37
From: WJ Shack <wjshack@anl.gov> Argonne Nat. Lab
To: Allen Hiser <ALH1@nrc.gov>, Ed Hackett <EMH1@nrc.gov> NRR
Date: 11/4/01 9:47PM
Subject: One last shot

Figure 10. Estimated stress intensity factors K_{est} for a CRDM nozzle. The conservative estimate of K developed in Section 6.4.2 is denoted as $K1$.

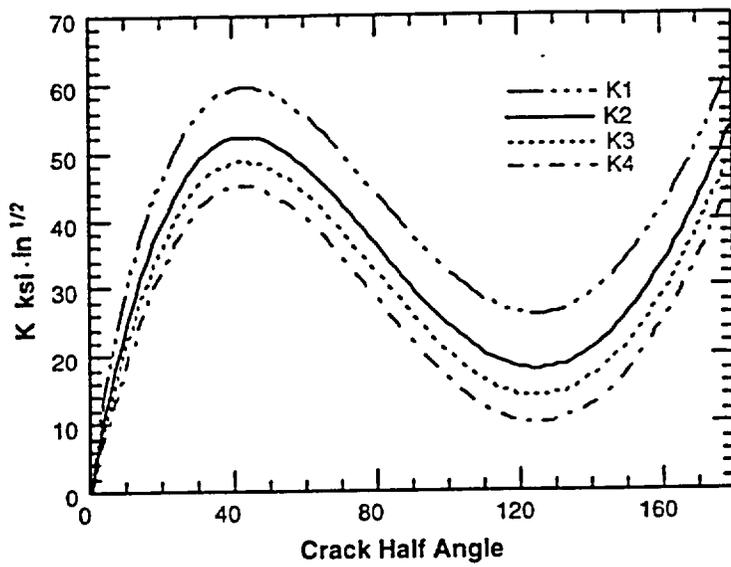
The two big factors in POF are plant to plant variations (about a factor of 20) and variation with K (about 4 orders of magnitude). In fact the POF changes more than 3 orders of magnitude with a change in K of 4 ksi in^{0.5}.

The variation from plant to plant is real. The variation with K is artificial. It arises from the assumption that all 69 nozzles have the same K. What we don't know and what seems like the highest priority to determine is what fraction of the nozzles have the high Ks and what fraction have low Ks. We will have to see what SIA, Gery, and Richard can do.

There is a kind of threshold behavior that is related to the steep part of the Scott curve. Three of my K distributions which drop the lowest K from 25 to 14 result in a change for Oconee of about a factor of 4 from 0.39 to 0.09. The next drop in the minimum K from 14 to 10 drops the failure probability by orders of magnitude. Conversely it would only take a relatively few high stress nozzles to get Oconee3 up to about 0.1 at 20 EFPY. Most other less susceptible plants would be 0.01 or lower.

Figure 13.
Variation of the cumulative probability of failure with EFPY assuming all nozzles have the K1 distribution.

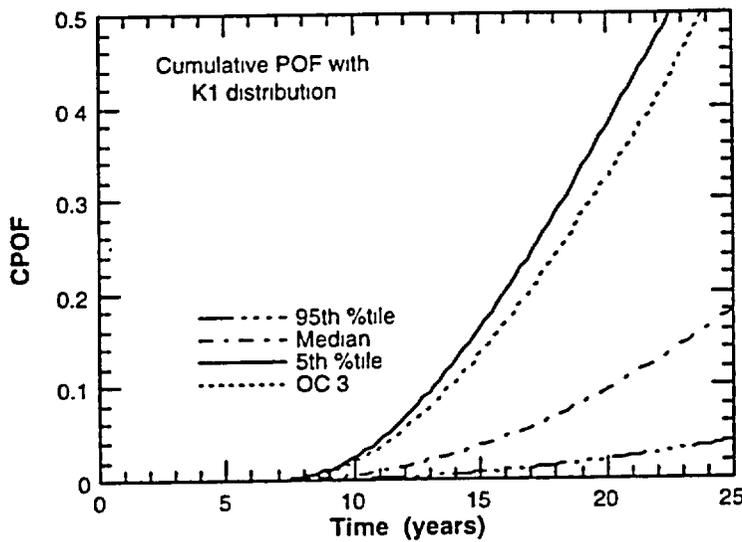
The calculations with the bounding K acting all 69 nozzles give probabilities that range from 0.39 for Oconee 3 (close to the 95th percentile plants) to 0.02 for other plants. The rate of increase in the CPOF for the 5th, 50th, and 95th percentile plants with this bounding K are 0.04, 0.013, and 0.003 per EFPY.
